DATE: August 15, 2023

RE: CEQA 15164 Determination for Proposed Post-Fire and Odor Management Engineering Design/Project Description Changes (PD Change No. 5): Finding that Section 15164 of the State CEQA Guidelines applies to minor changes to the ReSource Center at the Tajiguas Landfill. CEQA Guidelines Section 15164 allows an Addendum to be prepared when only minor technical changes or changes that do not create new significant impacts would result. The Final Subsequent EIR (SEIR)(12EIR-00000-00002, SCH #2012041068) and the SEIR Revision Letter and Errata dated May 27, 2016 and SEIR Addendum dated August 11, 2017 (revised October 26, 2017), 15162 determinations dated January 15, 2020, May 18, 2020, and August 2, 2021 are hereby amended by this Addendum.

Location: The project is located at the Tajiguas Landfill on Assessor's Parcel Numbers (APN) 081-150-042, 081-150-019 and 081-150-026, located approximately 26 miles west of the City of Santa Barbara, along the Gaviota coast, Third Supervisorial District.

Exhibit 1
MRF Site Plan

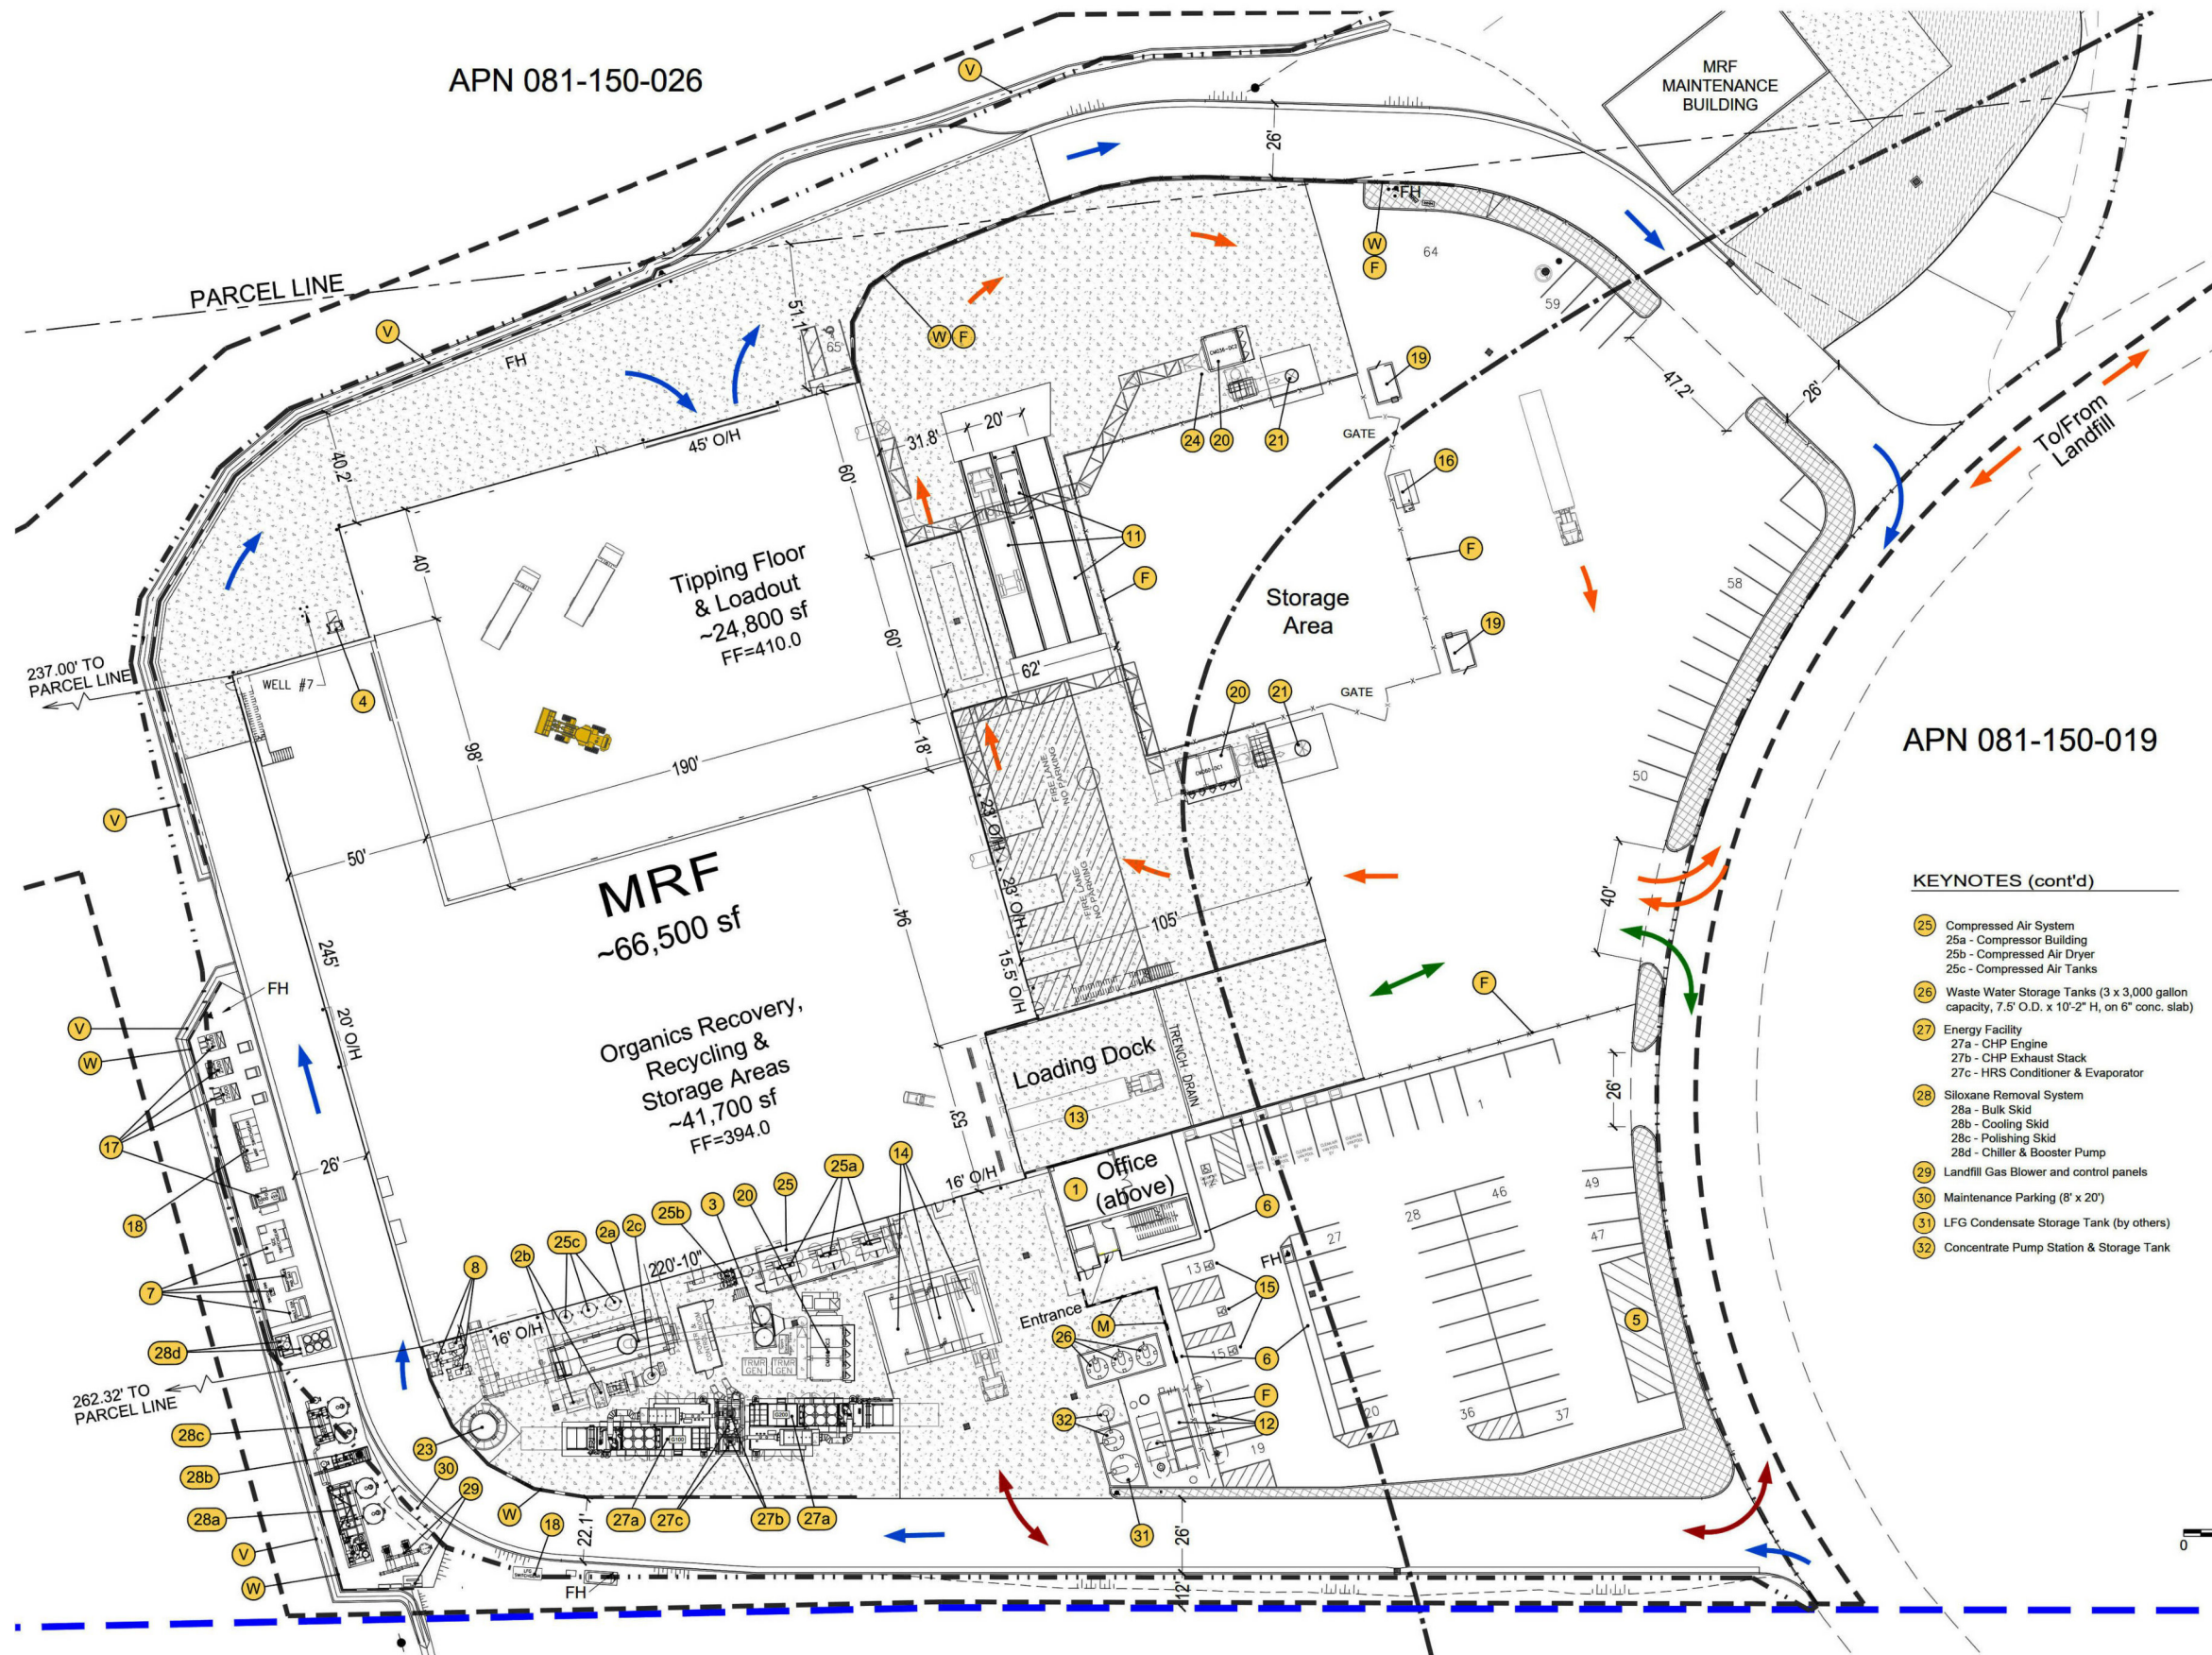
AECOM, the ReSource Center project air quality consultant, has re-evaluated the projected air quality emissions from the baghouses without the biofilters (refer to the Revised Air Quality Technical Memorandum for the ATC 14500 10 Application, Tajiguas ReSource Center, June 2023). The NH₃, H₂S and PM monitoring and air dispersion modeling shows that ambient air concentrations will remain within permit limits once the building air is again exhausted through the MRF baghouses. The baghouse filter support structures, which were damaged by the Alisal Fire, will be repaired and the two baghouses will exhaust the building air through two new separate vent stacks proposed to be constructed on the east side of the MRF in two locations adjacent to the biofilter site (see Exhibit 1 [keynote 21] and Exhibits 2 and 3).

The existing biofilter structural concrete perimeter, partition walls, and steel support structure will be demolished, and the scrubber concrete pads will be removed. The existing acid tank concrete pads and containment system will be removed. The existing asphalt and concrete paving in the proposed location of the new stacks will be sawcut and removed in order to construct the proposed stacks. All demolition material will be disposed of off-site. The former biofilter area is proposed to be used for storing excess recyclable recovery bales and large wood recovered during the recycling process. Any storage of material would be required to be in compliance with the facility's industrial storm water permit. The storage area would be fenced with an 8-foot-tall chain link fence, including slats, to provide visual screening and security of the recyclables (see Exhibits 1 and 3).

Tajiguas ReSource Center - 2022 Projects
Exhibit 2
 MRF Elevation Drawings

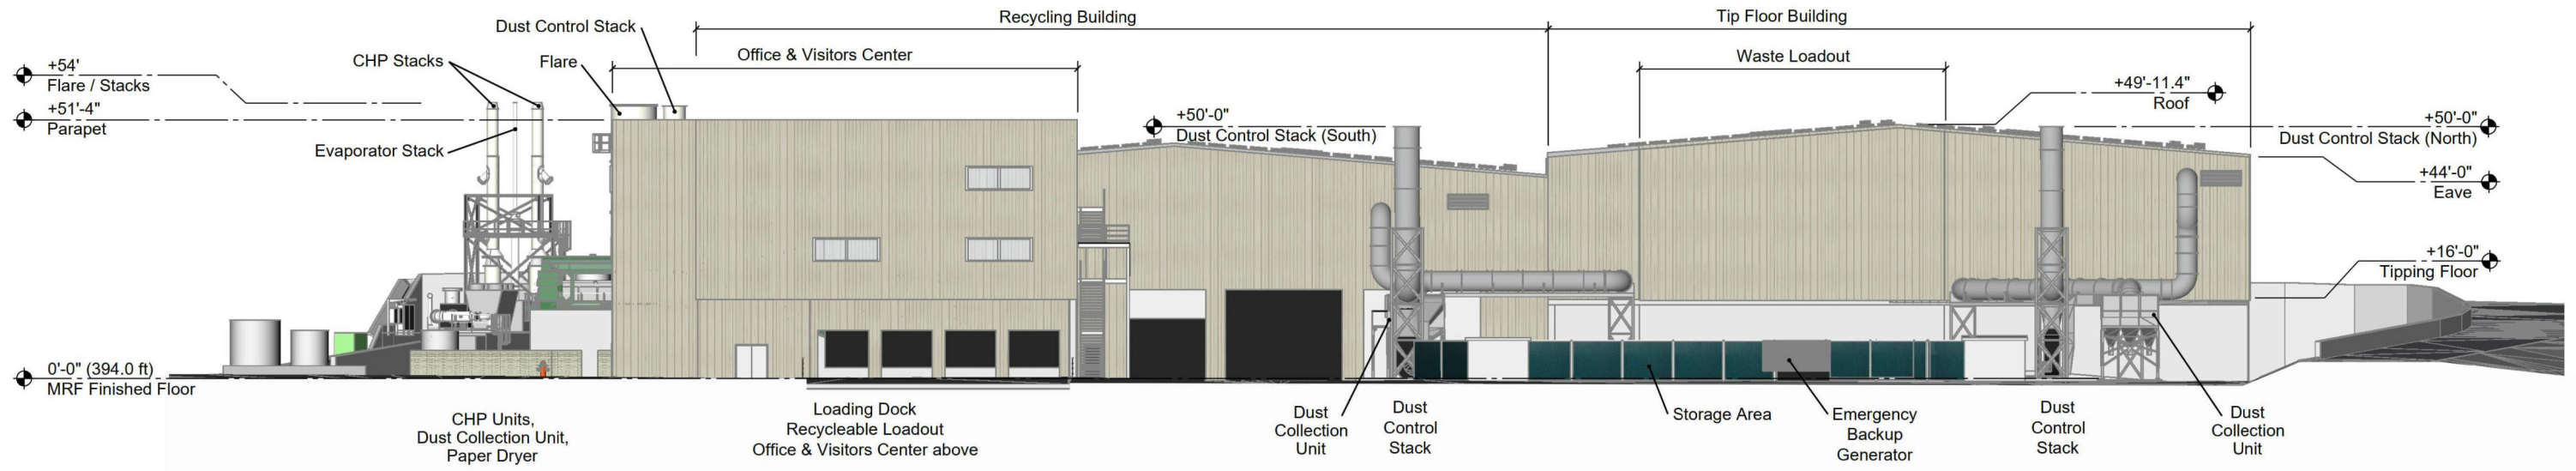
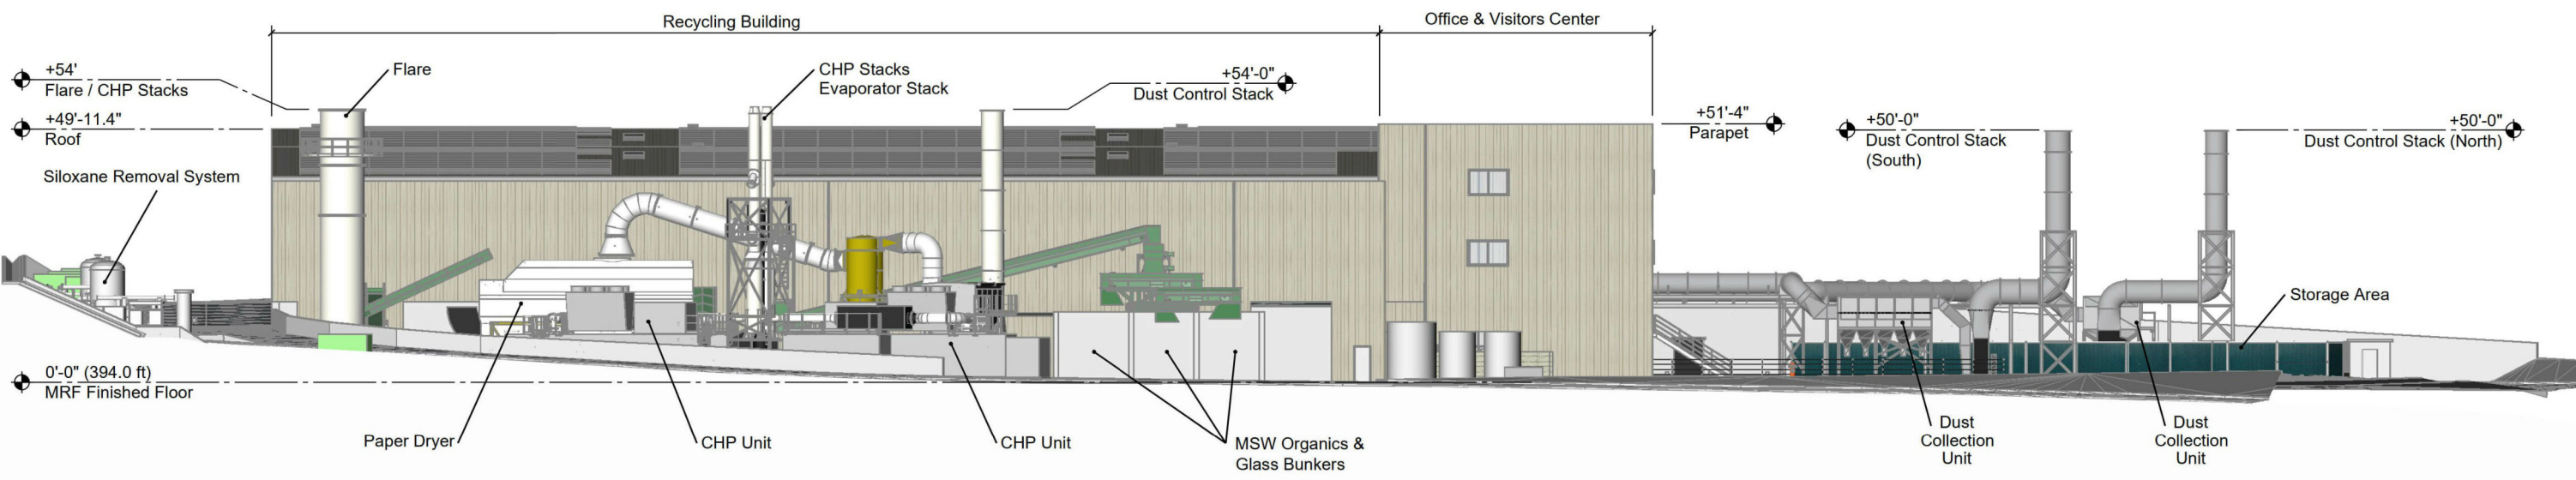
The proposed vent stacks will disperse the MRF building air collected and treated by the baghouse filters. Both stacks will be approximately 50-feet in height above existing grade. One new 54-inch diameter stack will be erected at the north end of the existing biofilter area. One new 66-inch diameter stack will be erected at the south end of the biofilter area. The two proposed vent stacks are required to be 50-feet in height to allow them to be higher than the adjacent buildings in order to provide the air dispersion necessary to meet air quality standards. In addition, because the MRF building air will not need to be brought to ground level for treatment in the biofilters, the stacks minimize energy use required for the system. The existing exhaust conduits exit the MRF building at a height of 36 feet. Without the biofilters, there is no longer a need to bring the exhaust down to ground level for treatment and dispersal. The air exhausted from the MRF building is the highest temperature air from within the MRF building, near the ceiling level. Less energy is consumed by the fans if the air within the MRF is discharged above the point where the exhaust conduit leaves the building.
